SERVICETEKNOTES

TABLE OF CONTENTS

Figure 1

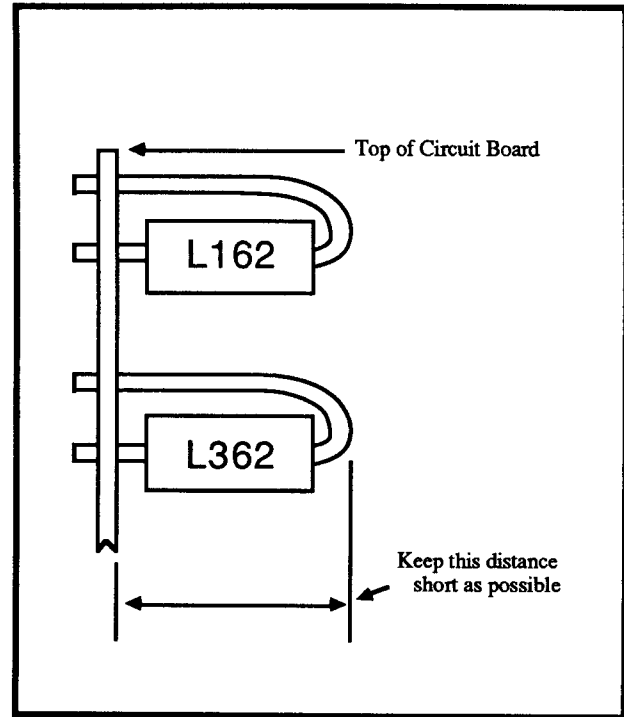
A small amount of residual subcarrier on the 1750 Series display has been traced to crosstalk from the DeMod board to the Vertical Amp board.

To alleviate this problem, Mod #65461 repositions A3L362 and A3L162 on the Vertical Amp board such that the coil bodies are perpendicular to the circuit board (see Figure 1).

Install this mod, as required, using two new coils, P/N 108-0317-00, in the configuration shown to help address residual subcarrier problems.

Figure 1 (Opposite Component Side)

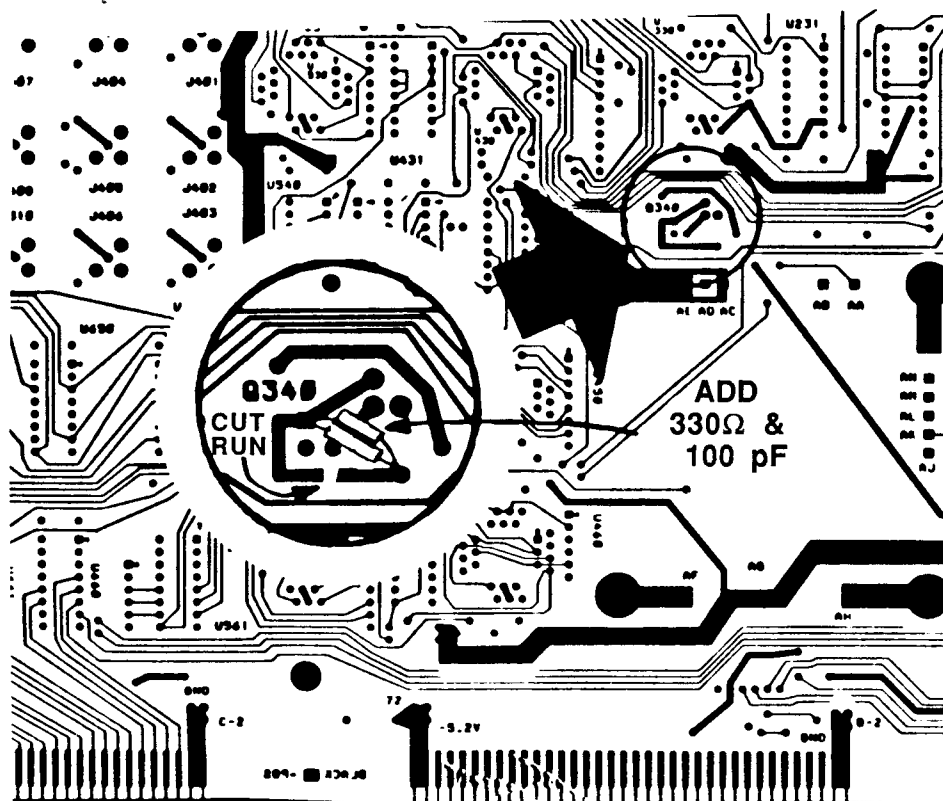
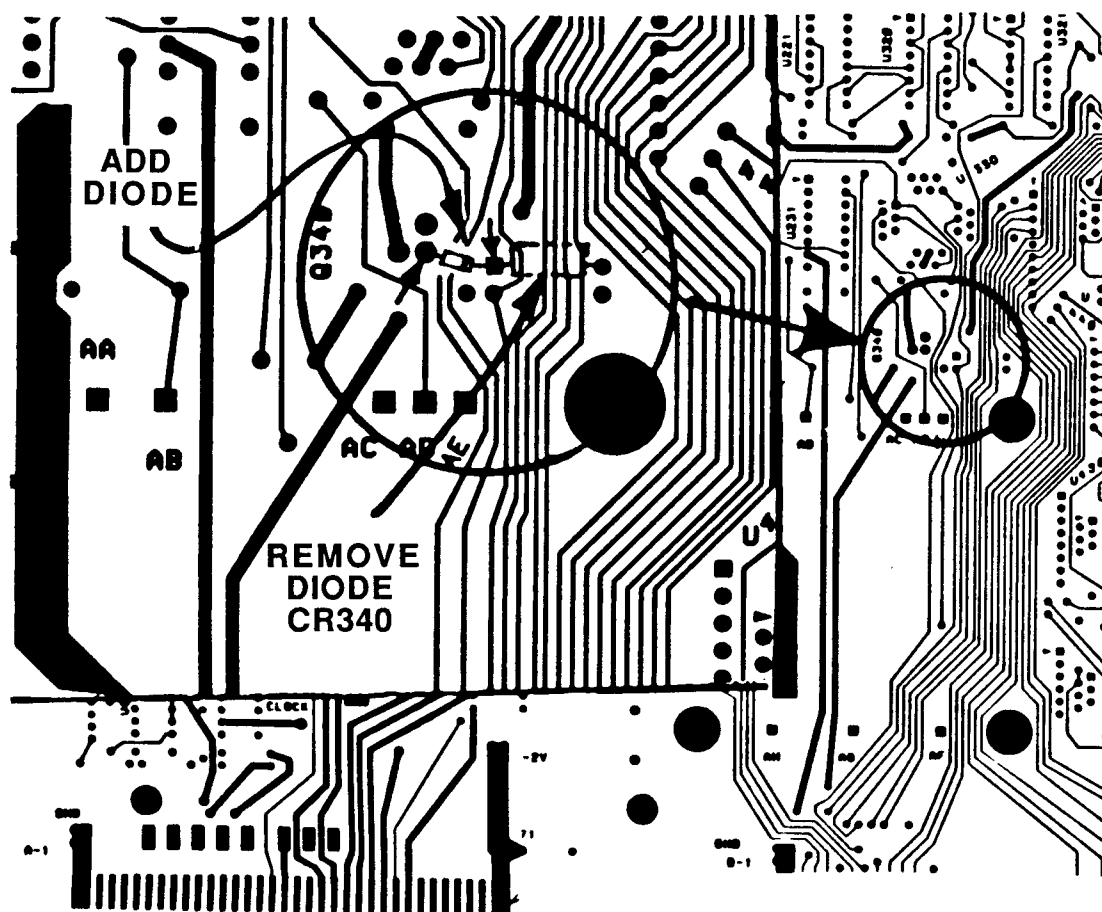
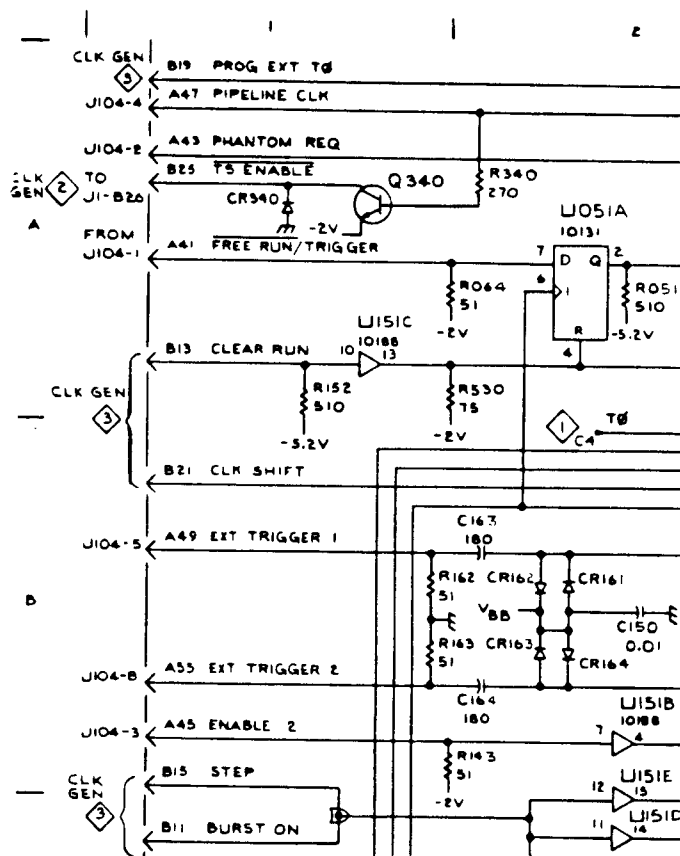
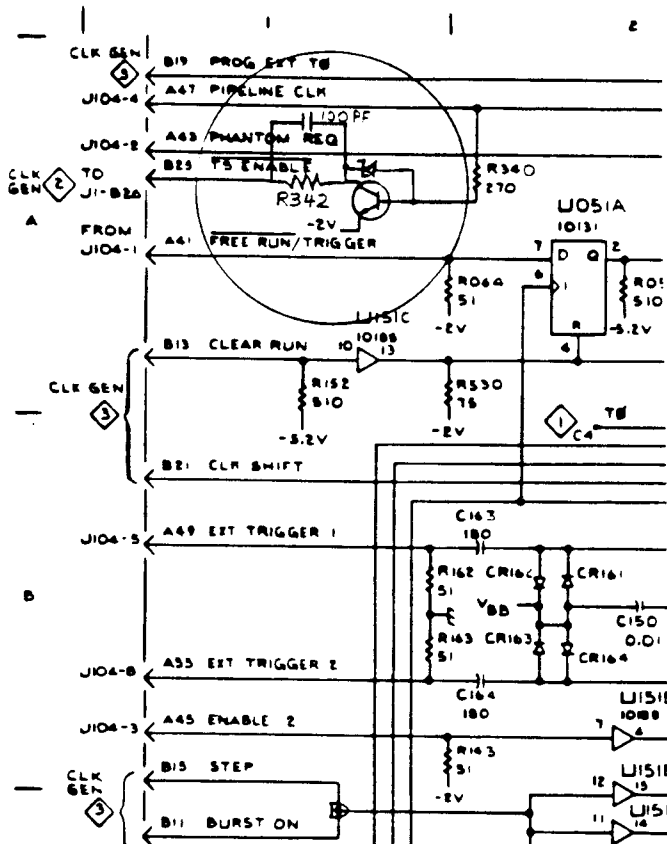
**S3295: CLOCK GENERATOR DESIGN
IMPROVEMENT, MODIFICATION
#64158**

The High Resolution Clock Generator Cycle Length Board, P/N 670-8219-02 is being modified to prevent U221 on the Interface Board from being overdriven. When the input signal to U221 is below the manufacturers specified limit of -0.3 V, logic errors might occur. Before this modification, the data bits used to select the desired clock phase might get corrupted. The modification involves using a voltage divider to attenuate the signal to the flip-flop, U221. A 100 pF capacitor is used to compensate for the slowed falling edge of the TS ENABLE signal. Also, a Schottky diode is added to prevent the ECL to TTL converter transistor, (Q340) from saturating.

1. Cut the circuit board run in the collector circuit of Q340 as shown in Figure 1*. This should be done on the back of the circuit board using an X-Acto knife or Dremel tool.
2. Add the 330 ohm resistor (R342), P/N 315-0331-00, and the 100 pF capacitor (C340), P/N 281-0765-00, as shown in Figure 1.
3. Remove the existing diode (CR340), P/N 152-0141-02, from the component side of the board (Figure 2).
4. Install the new CR340 Schottky diode, P/N 152-0725-01 from Collector to Base of Q340

(Figure 2). The before and after circuit diagrams are shown in Figures 3 and 4.

After the modification, the Cycle Length Board part number changes to 670-8219-03. The Cycle Length Assembly will change to 672-0087-01.
